SERVICE BULLETIN

APPLICABILITY: 2020-24MY Legacy & Outback 2.5L
 2017-24MY Impreza & Crosstrek
 2019-23MY Forester
 2022-23MY BRZ

NUMBER: 09-115-24R

SUBJECT: Oxygen Sensor Design Change / P0137, P0138, P0140, & P0141

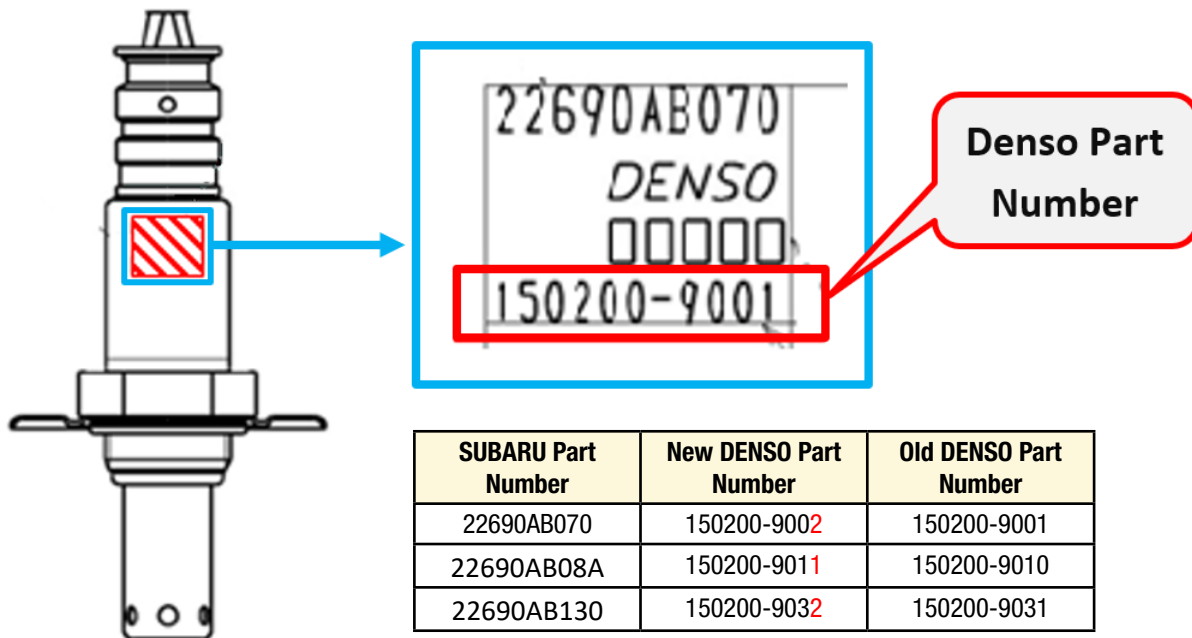
The new sensors have an optimized coating application to help prevent cracking within the internal surfaces reducing any possibility of short/open circuits. If any of the DTCs listed above are stored in the ECM, perform the sensor identification procedures outlined below.

The part numbers have not been changed. The new parts can be identified by the Denso part number engraved on the sensor.
